APPLICATION NO.	FILING DATE	FIRST NAMED INVENTOR	ATTORNEY DOCKET NO.	CONFIRMATION NO.
10/570,843	03/06/2006	Guofu Zhou	USQ30309	7364
24737 7590 12/26/2008 PHILIPS INTELLECTUAL PROPERTY & STANDARDS P.O. BOX 3001 BRIARCLIFF MANOR, NY 10510				
EXAMINER				
STEINBERG, JEFFREY S				
ART UNIT		PAPER NUMBER		
4193				
MAIL DATE		DELIVERY MODE		
12/26/2008		PAPER

Office Action Summary

DETAILED ACTION

FIG-2

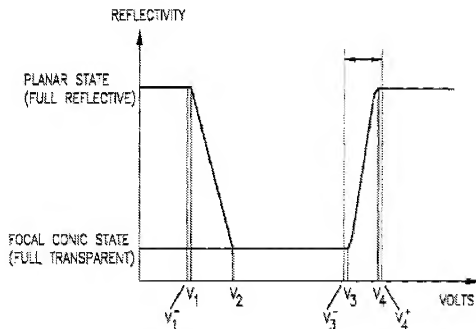
Regarding Claim 6, the EPO '519 fails to disclose that the data-dependent portion of each of the voltage waveforms comprises a drive portion. Blackson teaches, specifically, in Fig 2 (reproduced immediately above) as explained in Column 4, lines 25-38 of the reference EPO('519) and Blackson are analogous because they are from the same field of endeavor, i.e. display devices. It would have been obvious to one having ordinary skill in the art at the time the invention was made to modify the Display Device disclosed by EPO '519 by the teachings of Blackson, since such a modification would have improved the performance of the display.
